The amendments remove operability and surveillance requirements for the High Pressure Coolant Injection (HPCI) turbine steam line isolation in the event of HPCI room inlet/outlet ventilation high differential temperature.

The Commission has issued the enclosed Amendment Nos. 5 and 27 to Facility Operating Licenses Nos. DPR-71 and DPR-62 for the Brunswick Steam Electric Plant, Units Nos. 1 and 2. The amendments consist of changes to the Technical Specifications in response to your request dated August 4, 1976, as supplemented January 31, 1977.

# SAFETY EVALUATION BY THE OFFICE OF NUCLEAR REACTOR REGULATION

# SUPPORTING AMENDMENT NO. 5 TO FACILITY OPERATING LICENSE NO. DPR-71

3.2-9

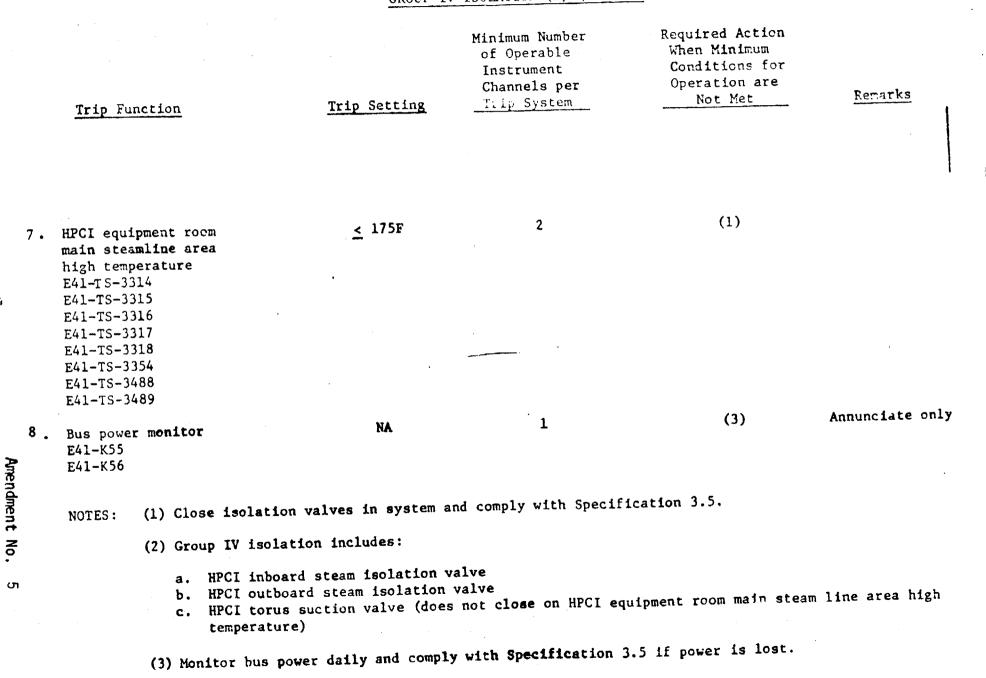
Revise Appendix A-Prime as follows:

Remove the following pages and replace with identically numbered revised pages:

3/4 3-11 3/4 3-14 3/4 3-17 3/4 3-19

Revise Appendix A as follows:

Remove the following pages and replace with identically numbered revised pages:

3.2-9/3.2-10 3.2-11/3.2-12

Trip Function	Trip Setting	Minimum number of Operable Instrument Channels per Trip System	Required Action When Minimum Conditions for Operation are not Met	Remarks
	1.	Steamline high d/p (steamline break)	<300% rated flow	2	(1)	
		E41-dPIS-N004 E41-dPIS-N005 HPC1 turbine steam- line low pressure	100 (+ 3) psig	2	(1)	
	3.	E41-PSL-NOO1A.B.C.D HPCI turbine exhaust diaphragm high pressure	10 ( <u>+</u> 0.7) psig	2	(1)	
Amendment No.	4.	E41-PSH-NO12A,B,C,D Suppression pool high ambient temperature E51-TS-N603C,D	≤ 200F	2	(1)	
	5.		≤50F	2	(1)	
ர		. Emergency area cooler high temperature E41-TS-N602A,B	≤175 <b>₽</b>	2	<b>\-</b> /
